Re: Dana Reserve Specific Plan Draft Environmental Impact Report

I serve as legal counsel to the Nipomo Community Services District (“NCSD” or “District”). On behalf of NCSD, we submit the following comments on the Draft Environmental Impact Report (“DEIR”), State Clearinghouse No. 2021060558, dated June 2022, which was prepared by San Luis Obispo County (“County”) in connection with the proposed Dana Reserve Specific Plan and associated land use entitlements (the “project”). As noted in the DEIR, NCSD is a responsible agency for the project as defined in CEQA Guidelines Section 15381, and would rely on the Final EIR (if certified by the County) as a part of its consideration of the project developer’s application for annexation into the District.

Figure 2-1

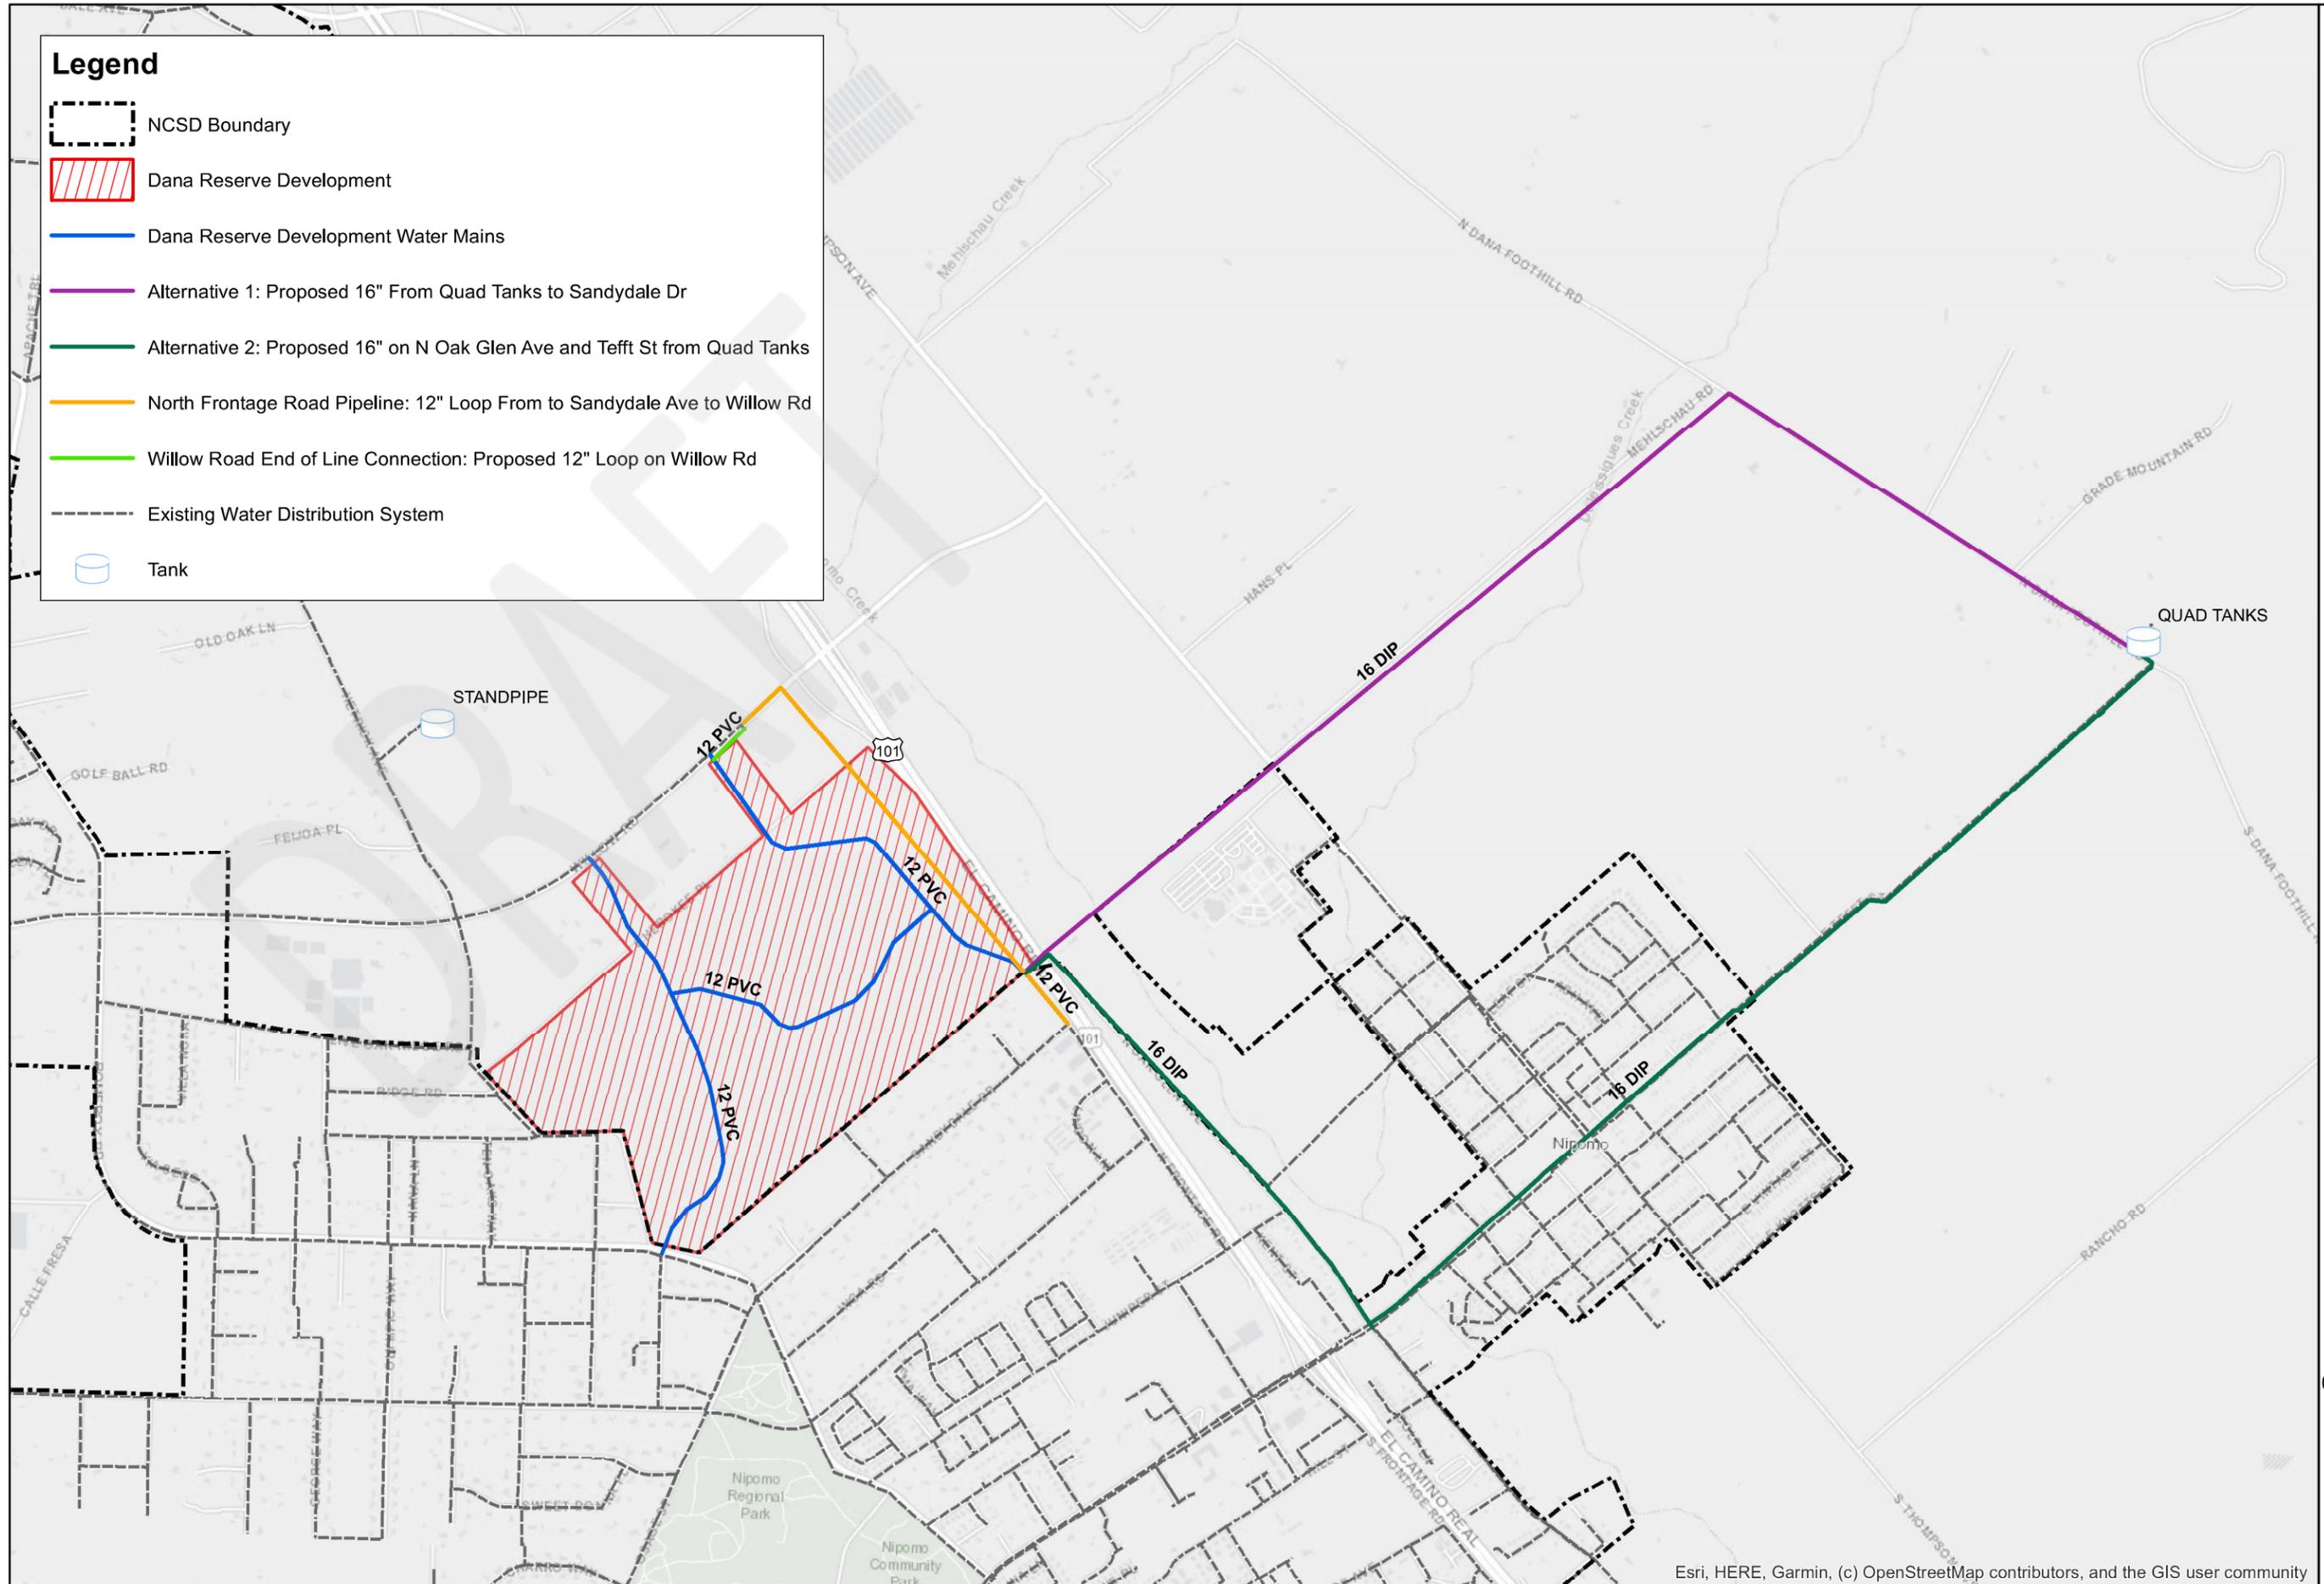
22. Page 2-25: Are ADU estimates included in the number of units listed in Table 2.5?
23. Section 2.5.3.4.3 and Figures 2-20, 2-21 and 2-22: The text should note that all water and sewer lines dedicated to, and accepted by, NCSD must be located within public streets or dedicated property. NCSD does not accept easements unless no reasonable alternative exists. For new development, the project can be designed to avoid using easements alternatives. On Figures 2-20 and 2-22, and on figures 4.19-2 and 4.19-3, please clarify that the labeled 16" water line and 12" sewer line do not currently exist.
